# Value Engineering Study No. 201905 – Report

**KY 80 and KY 461 Interchange and KY 461  
Widening**

*Pulaski County*

December 16 through 19, 2019

<b>DESIGN CONSIDERATION NO. 19: CONNECT PARCEL 38 ACCESS TO JUG-HANDLE</b>	<b>Idea No. 25</b>
--	------------------------

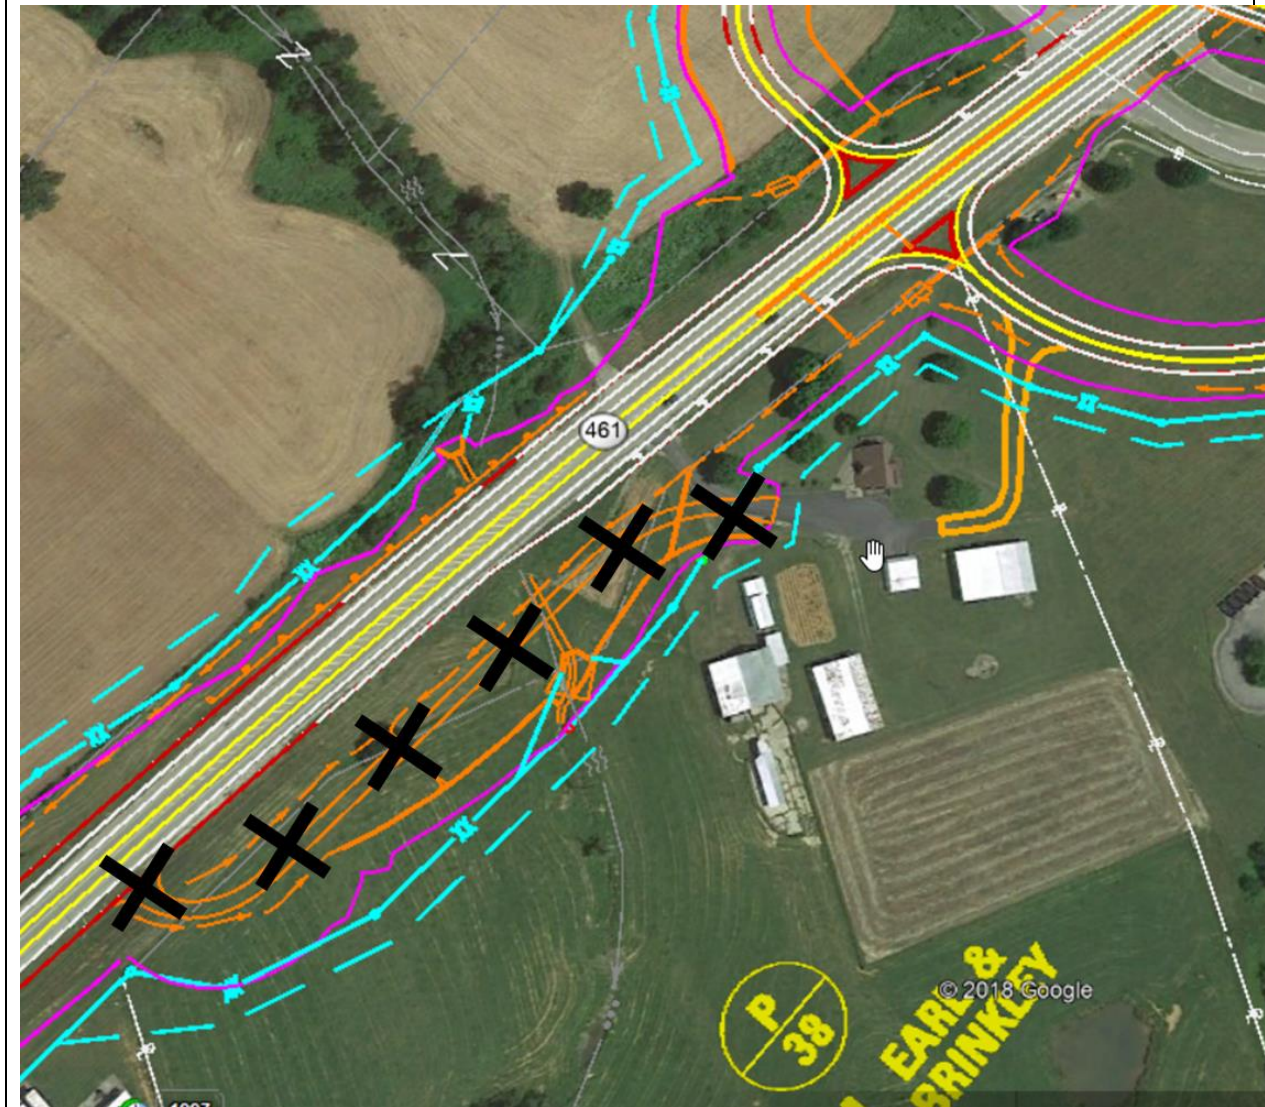
<b>DESIGN CONSIDERATION NO. 19: CONNECT PARCEL 38 ACCESS TO JUG-HANDLE</b>		<b>Idea No. 25</b>
<b>Baseline Concept</b>		
KY 461 access to/from Parcel 38 is achieved at the south end of the property.		
<b>Suggested Concept</b>		
Access Parcel 38 to/from the jug handle adjacent to the property.		
<b>Advantages</b>		<b>Disadvantages</b>
<ul style="list-style-type: none"> <li>• Less pavement</li> <li>• Remove one access point on KY 461</li> <li>• Reduce pipe extension</li> <li>• Reduces overall right-of-way required</li> </ul>	<ul style="list-style-type: none"> <li>• May require small amount of right-of-way to connect to “ramp”</li> <li>• Access off of “ramp”</li> </ul>	
<b>Discussion</b>		
<p>The purpose and need of the project is to enhance safety, enhance mobility, and build a free flow facility on KY 461. Through the function analysis phase of the VE study, one way to enhance safety and enhance mobility is to reduce conflict points.</p> <p>Relocating this access point to the jug handle removes multiple conflict points on KY 461 (see graphic on the following page).</p>

<b>DESIGN CONSIDERATION NO. 20:                  GRADE SEPARATE EXISTING RAMP B ALIGNMENT WITH                  RAMP F</b>	<b>Idea No.                  27</b>
--	---

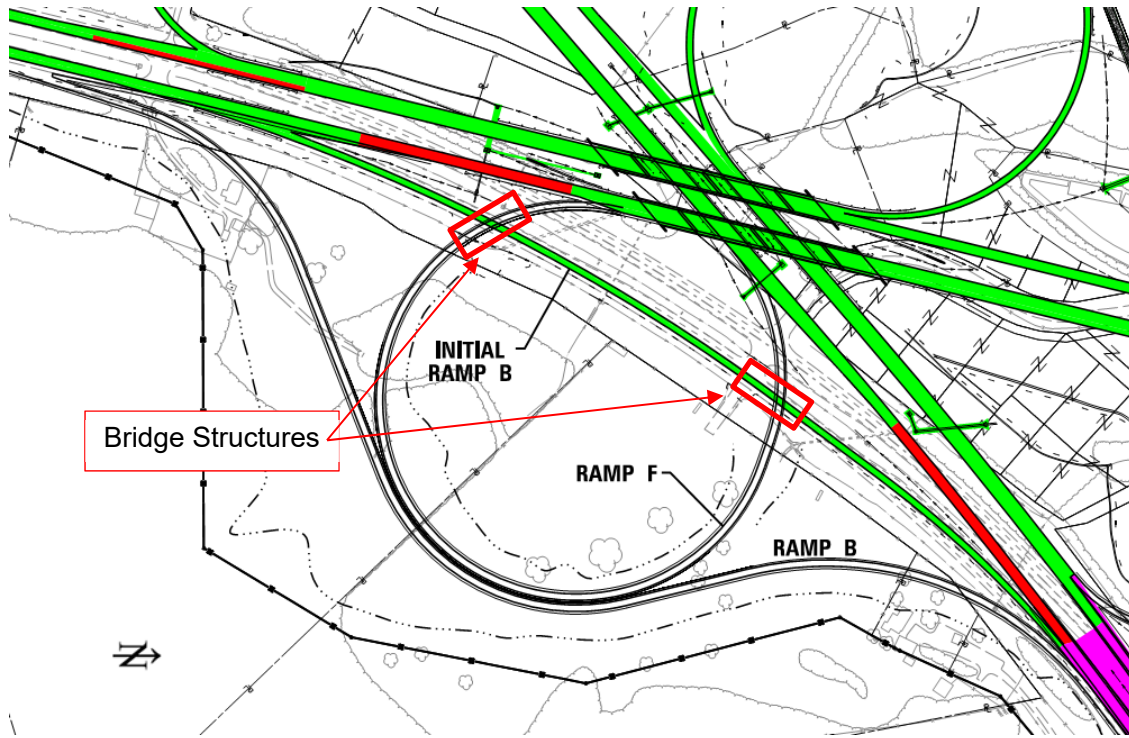
DESIGN CONSIDERATION NO. 20: GRADE SEPARATE EXISTING RAMP B ALIGNMENT WITH RAMP F		Idea No. 27	
<b>Baseline Concept</b>			
Use initial ramp B; when ramp F is built, construct ramp B ultimate condition.			
<b>Suggested Concept</b>			
Grade separate Initial Ramp B alignment with Ramp F, eliminating future Ramp B			
<b>Advantages</b>		<b>Disadvantages</b>	
<ul style="list-style-type: none"> <li>• Reduce project footprint (earthwork)</li> <li>• Better geometry</li> <li>• Less pavement when tied in with Northern Bypass</li> <li>• Eliminates opposing traffic/headlights</li> </ul>		<ul style="list-style-type: none"> <li>• Additional structure costs</li> <li>• Additional embankment</li> </ul>	
Cost Summary		Capital Cost	Total Cost
Baseline Concept		\$1,137,000	\$1,137,000
Recommendation Concept		\$1,290,000	\$1,290,000
Cost Avoidance/(Added Value)		\$(152,000)	\$(152,000)
<p>The VE team recommends using the Initial Ramp B and incorporate a grade separation with ramp F, which would allow eliminating future ramp B. The VE team believes this option would allow the overall footprint of the project to be reduced because Ramp B would not need to be built. An initial rough measurement of the plans showed that a 3 to 4 percent grade would be implemented to get the grade separation of initial ramp B over ramp F. Another benefit would be the overall reduction in earthwork for not having to construct ramp B. This would reduce pavement costs in any future projects of tying in the Northern Bypass. The downside is that cost in savings of pavement could disappear because additional structures would be needed to implement the grade separation of initial ramp B over ramp F.</p> <p>The following image helps illustrate the location of the structures in this configuration.</p>
